OVERLOOK AT HOMESTEAD FILING NO. 1 PRE DEVELOPMENT GRADING AND EROSION CONTROL PLAN

OVERLOOK AT HOMESTEAD FILING NO. 1
EL PASO COUNTY, COLORADO
PRE DEVELOPMENT GEC PLAN
COVER SHEET

SHEET
1.11

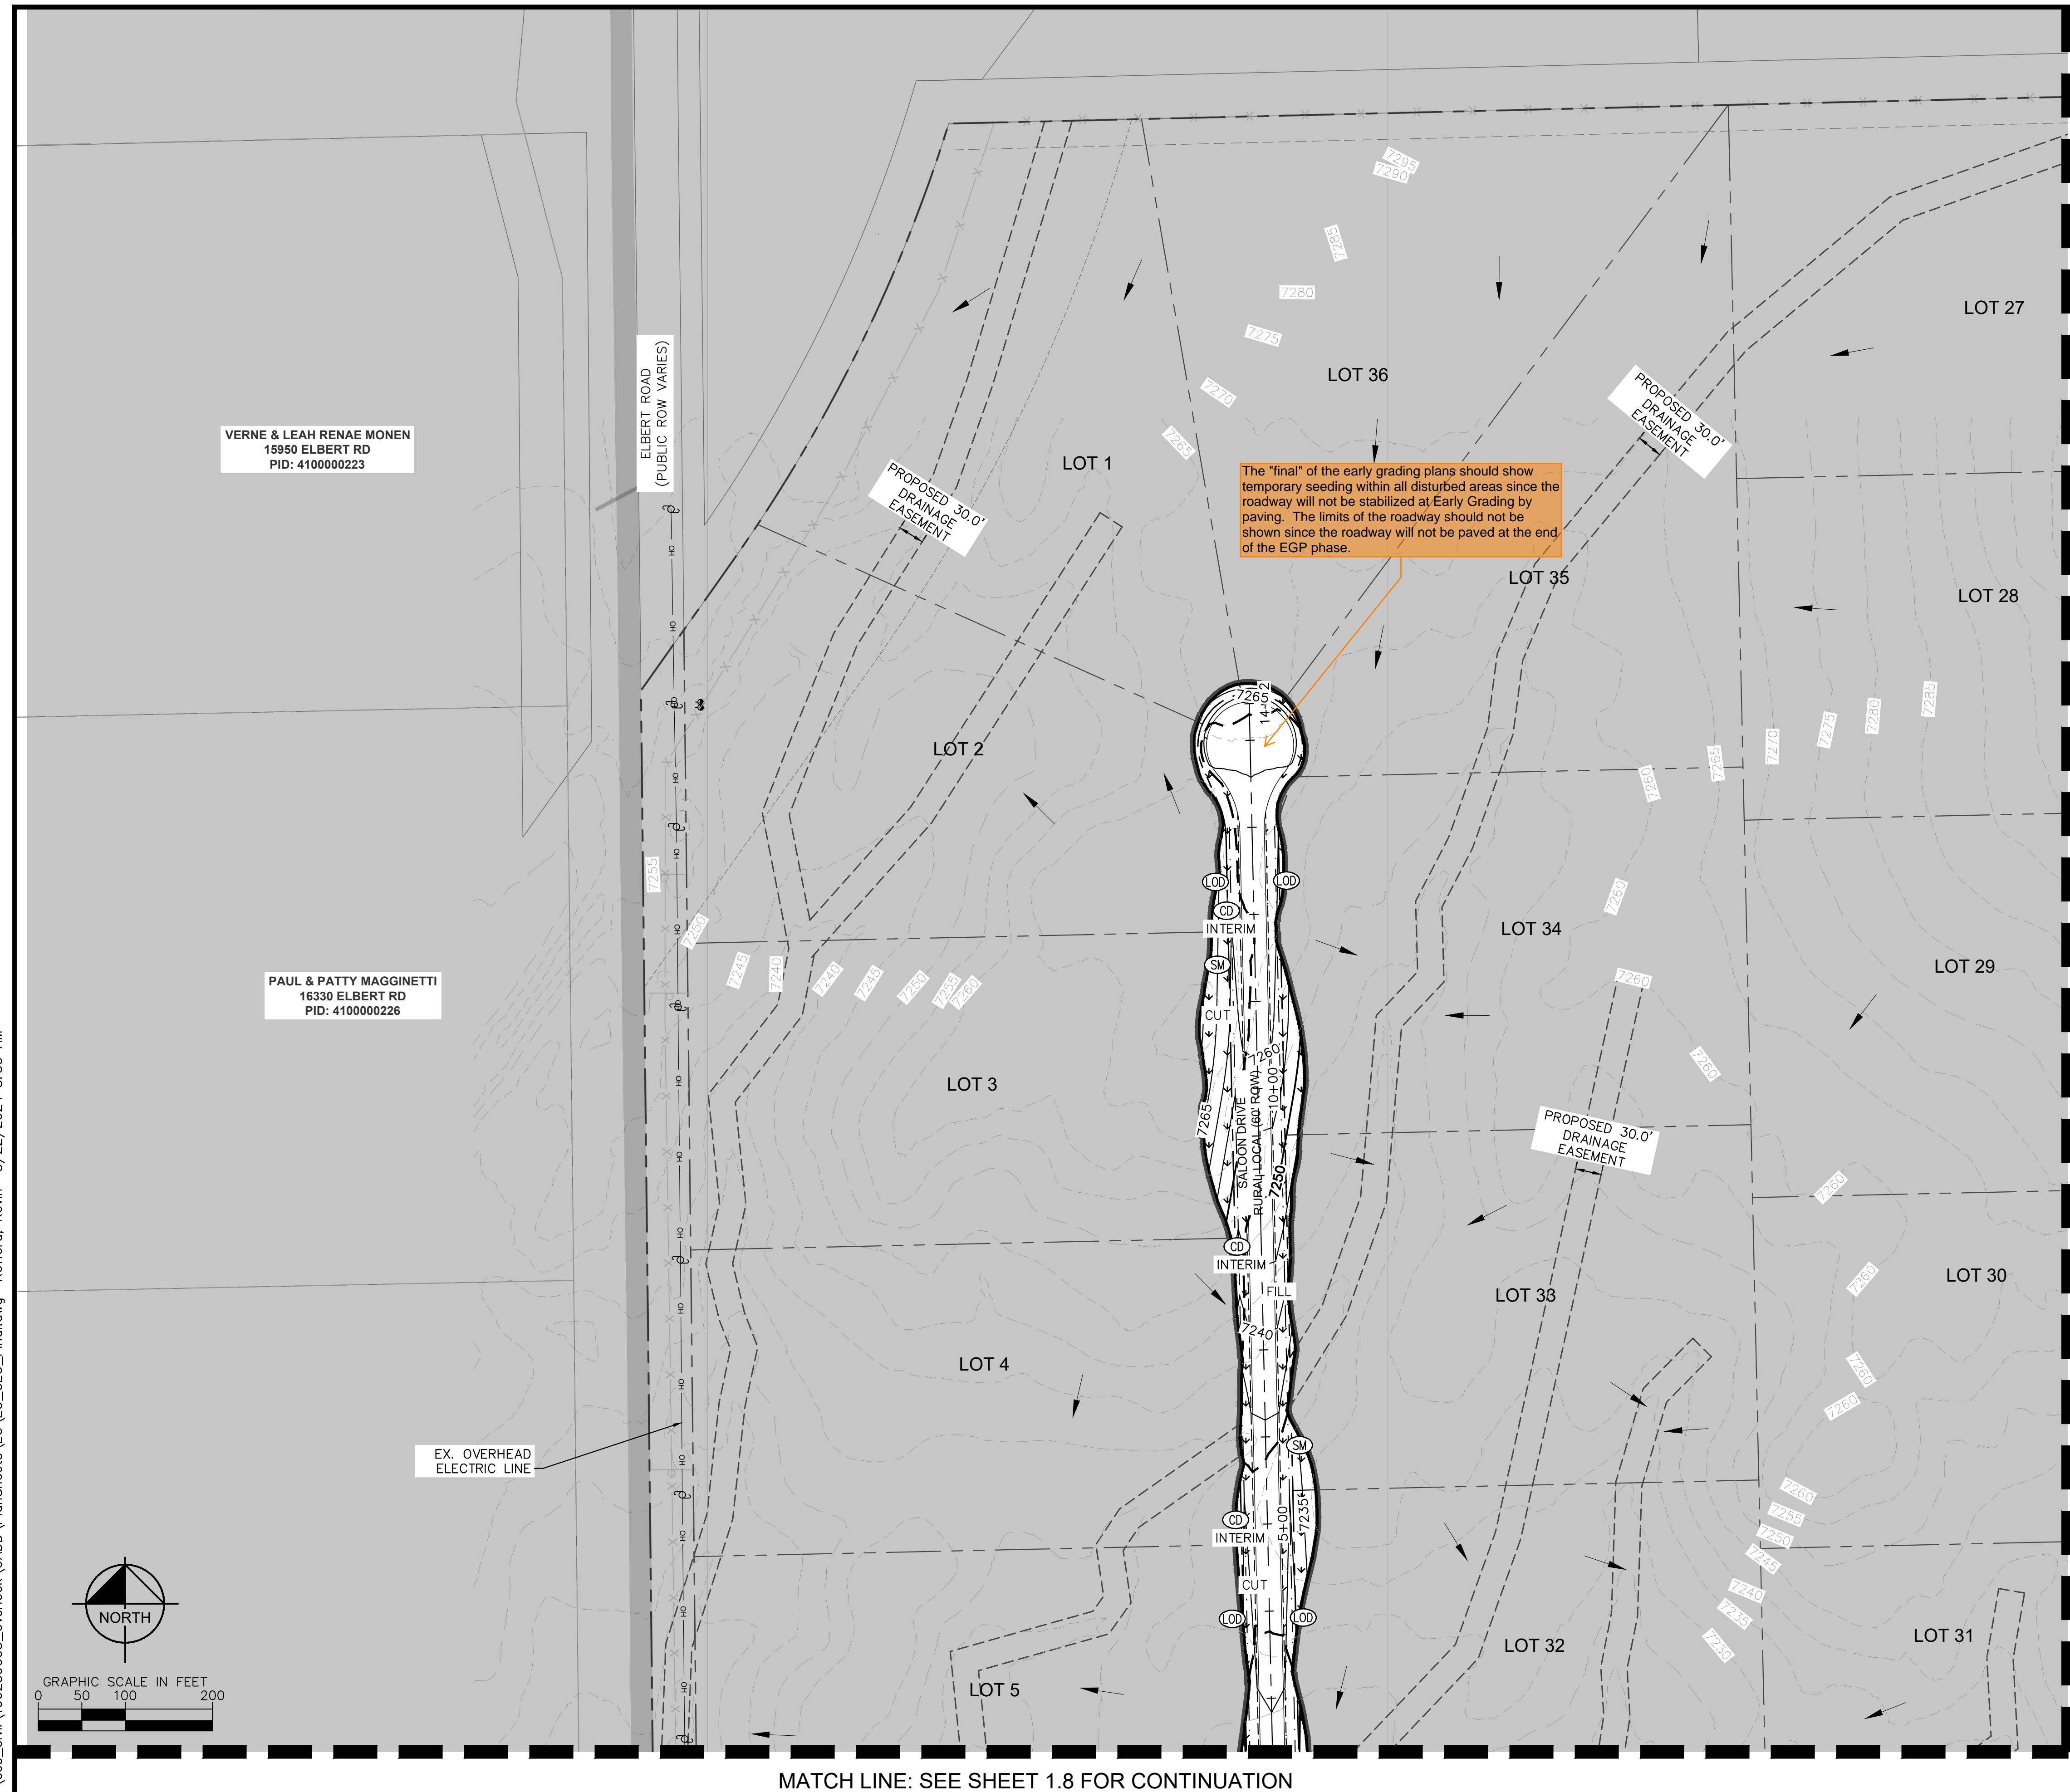
The "final" of the early grading plans should show temporary seeding within all disturbed areas since the roadway will not be stabilized at Early Grading by paving. The limits of the roadway should not be shown since the roadway will not be paved at the end of the EGP phase.
